**ITB-20-13
ADDENDUM #3 - FINAL
CITY HALL OFFICE REMODEL**

Date: September 25, 2020
Bid Number: ITB-20-13
Bid Due Date: THURSDAY, OCTOBER 1, 2020 BY 1:00 PM OUR CLOCK

Existing Fire Alarm Panel

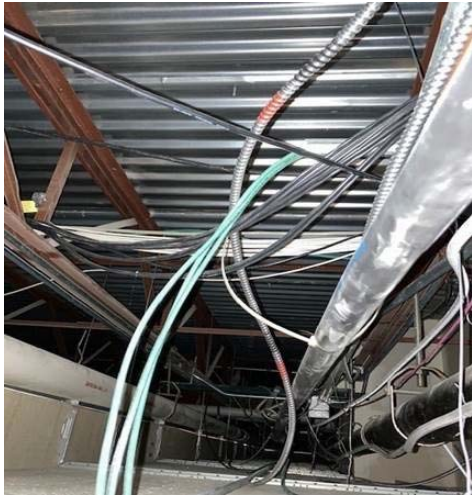
16. Is there any Fire Alarm work required as part of this contract? [We would expect there to be some minimal Fire Alarm and Fire Protection Scope of Fire work to be determined by General Contractor and permitted \(as required\) as a deferred submittal. See attached photos](#)
